Model: Model Sh-P1 PFU option		Date: 24-Feb-12	No.: RM386001
Subject: Part catalog correction		Prepared by: T.Hirai	
From: 3rd Tech Service Sect., MFP/P Tech Service Dept.			
Classification:	<input type="checkbox"/> Troubleshooting <input type="checkbox"/> Mechanical <input type="checkbox"/> Paper path <input type="checkbox"/> Product Safety	<input checked="" type="checkbox"/> Part information <input type="checkbox"/> Electrical <input type="checkbox"/> Transmit/receive <input type="checkbox"/> Other ()	<input type="checkbox"/> Action required <input type="checkbox"/> Service manual revision <input type="checkbox"/> Retrofit information <input type="checkbox"/> Tier 2

Model: Model Sh-P1 (PFU)		Date: 08-May-12	No.: RM386002
Subject: Check point at installation (Tray side fences or Paper end sensor were detached)		Prepared by: T.Hirai	
From: 3rd Tech Service Sect., MFP/P Tech Service Dept.			
Classification:	<input type="checkbox"/> Troubleshooting <input type="checkbox"/> Mechanical <input type="checkbox"/> Paper path <input type="checkbox"/> Product Safety	<input type="checkbox"/> Part information <input type="checkbox"/> Electrical <input type="checkbox"/> Transmit/receive <input

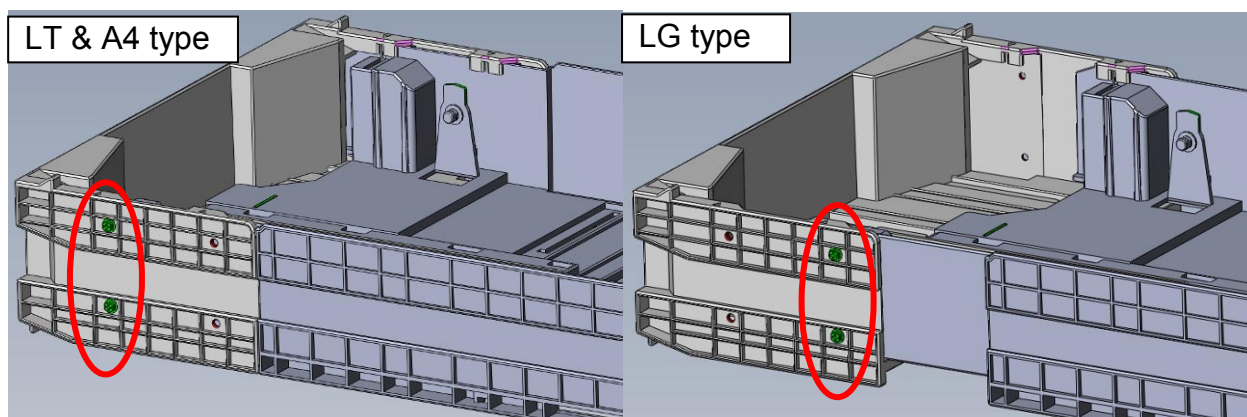
The shape of the stopper was changed, and four screw holes were added so that the extension tray can be fixed in place for LT/A4 and LG paper sizes.

Important: *If there is no available screw hole in the user's tray, replace the tray with the following new part (which contains the required screw holes).*

- The new screw holes are for LT/A4 and LG paper sizes. If the user always uses the same paper size, fix the extension tray in place at the corresponding position. ***If the user does not always use the same paper size, fix the extension in place for LG sized paper.***
- Insert the screws from the outside face of the tray. For each paper size, there are two screw holes, as shown.
- Be careful not to over-tighten the screws.

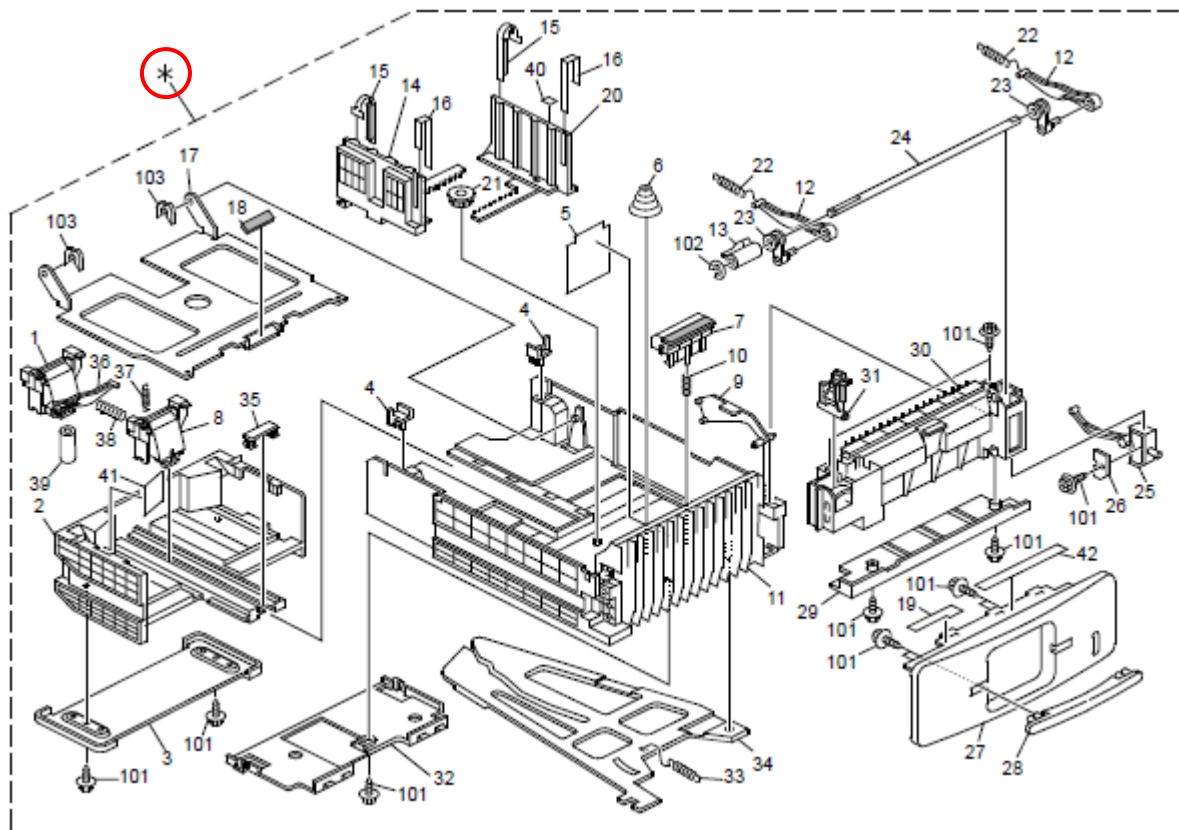
Part Number	Description	Q'ty	Int	Page	Index	Note
M3752550	PAPER TRAY:ASS'Y	1	-	5	*

Change/ Reason: This part number was missing from the parts catalog.

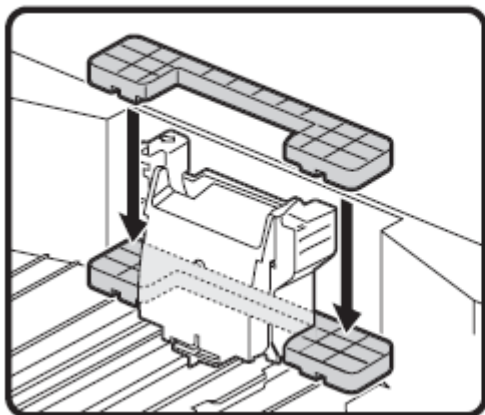
- A.** A spacer was added behind the end fence.
- B.** An instructional leaflet for users was inserted in the paper tray.
- C.** The end fence is fixed in the LT position before shipment from the factory. (The side fences are fixed in the A4 position.)
- D.** ***A spacer with reinforced double-sided tape was added (P/N: M0212570).***

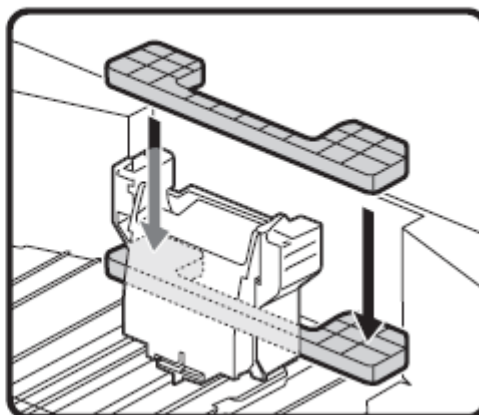
Attach the following parts (***P/N: M0212570***) behind the end fence, as shown, using double-sided tape.

2.Paper Feed Unit 2 (M386/M389)

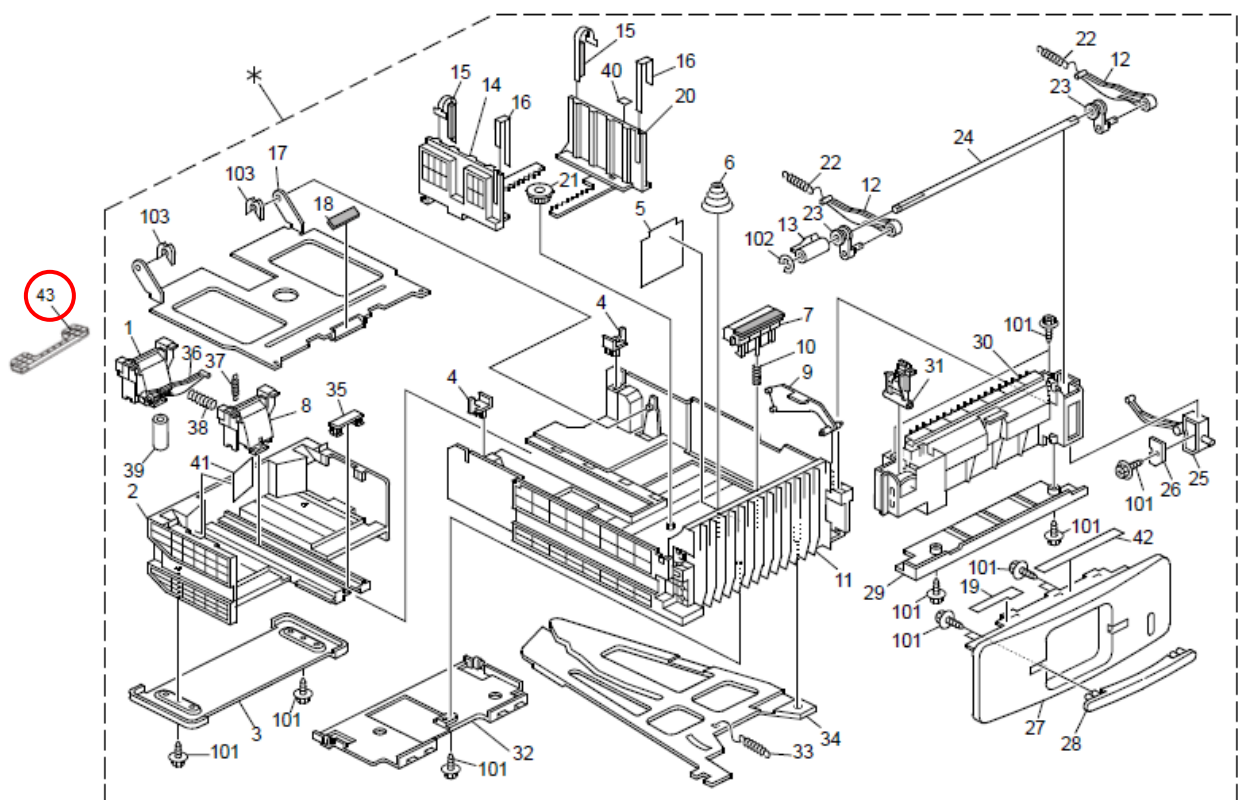
Old part number	New part number	Description	Q'ty	Int	Page	Index	Note
	M0212564	END FENCE:SPACER	0-1	-	5	43

Change: A spacer was added.

Reason: To make sure that the operator sets the end fence in the correct position.

2.Paper Feed Unit 2 (M386/M389)

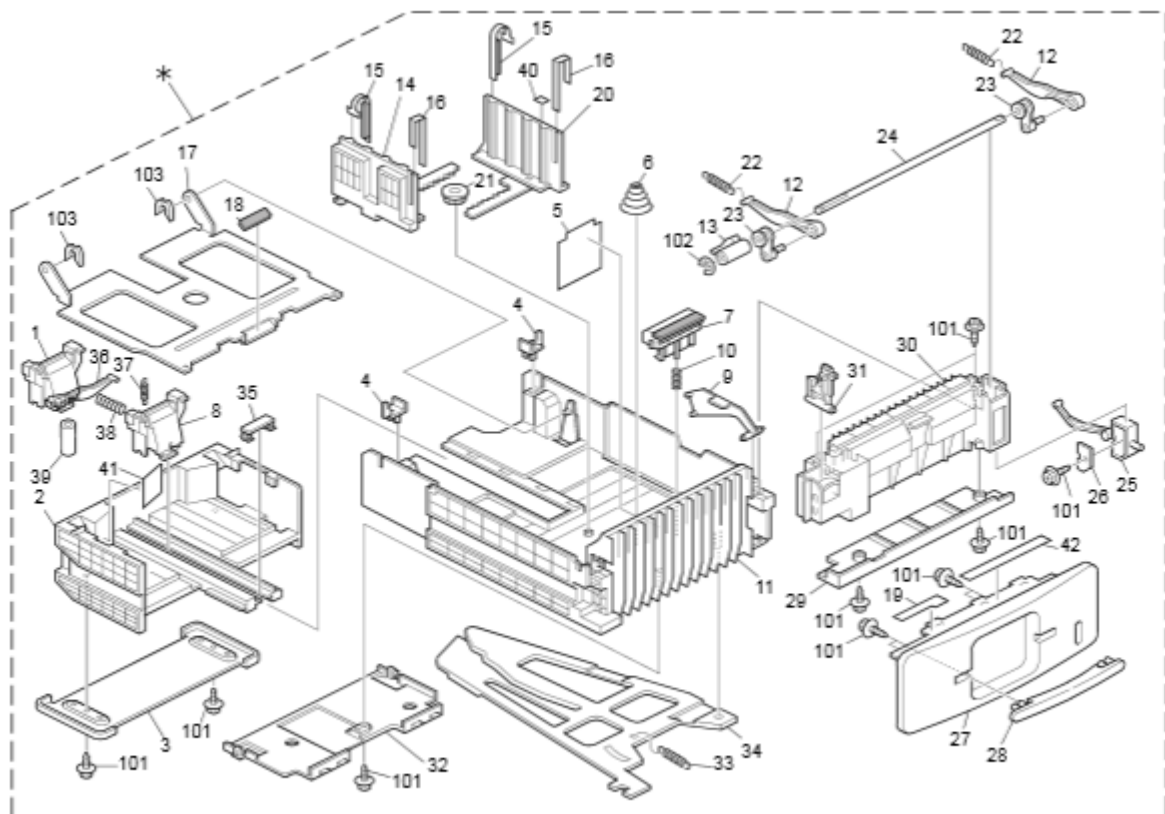
Change/Reason: The following part number and index number were changed.

Old part number	New part number	Description	Q'ty	Int	Page	Index
M0212659	M0522670	TRAY BOTTOM PLATE	1	-	5	17

3.Paper Feed Unit 3 (M386/M389)

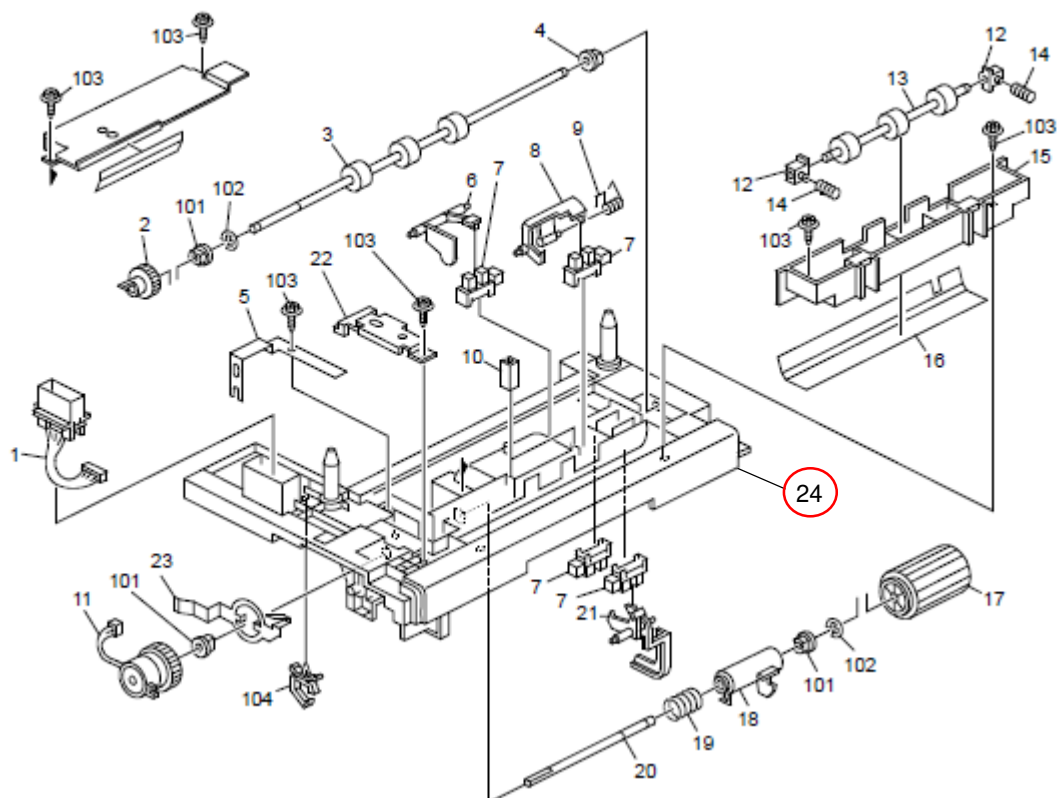
Old part number	New part number	Description	Q'ty	Int	Page	Index	Note
	M3752556	HOUSING:PAPER FEED UNIT:UPPER	1	-	7	24	Add

Change: The following part was newly added as a service part.

3.Paper Feed Unit 3 (M386/M389)

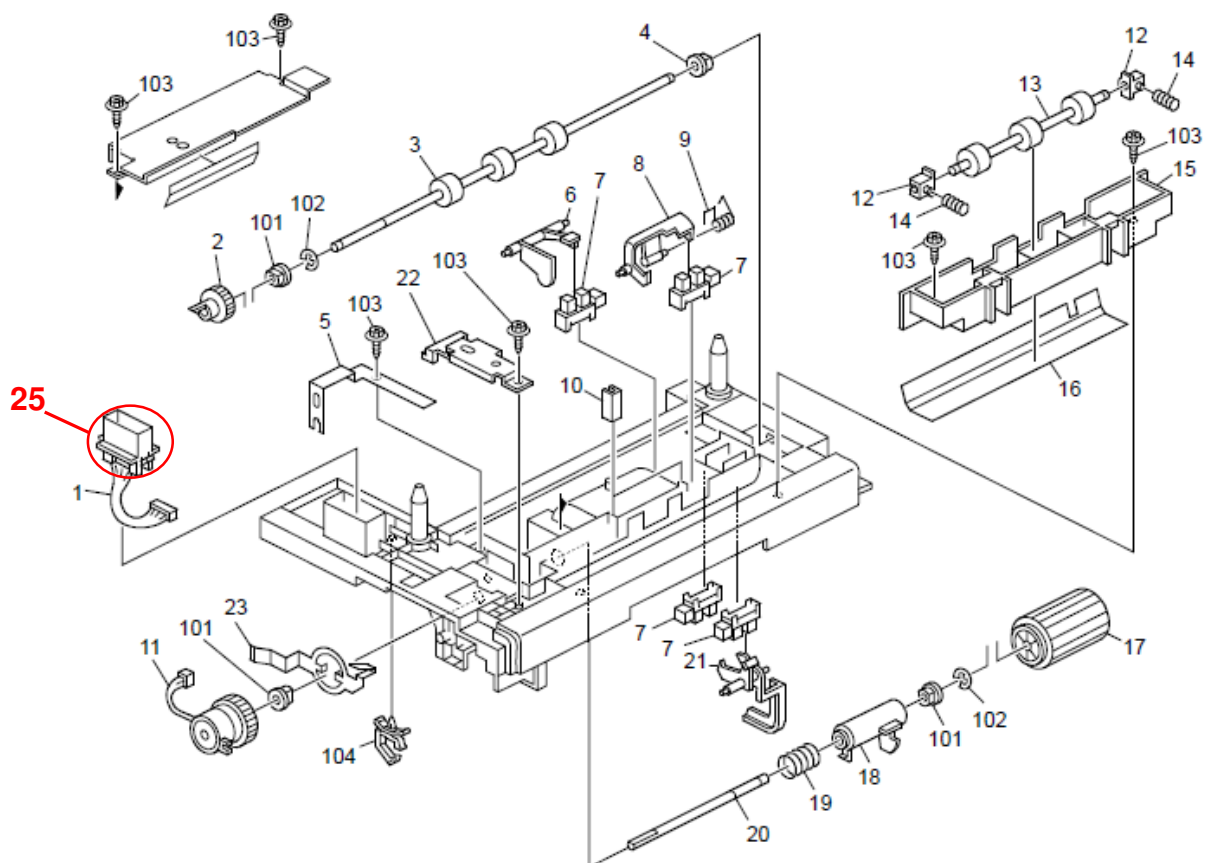
Change/Reason: This part number was missing from the parts catalog.

Part number	Description	Q'ty	Int	Page	Index	Note
11029811	CONNECTOR:1-1612256-4	1	-	7	25
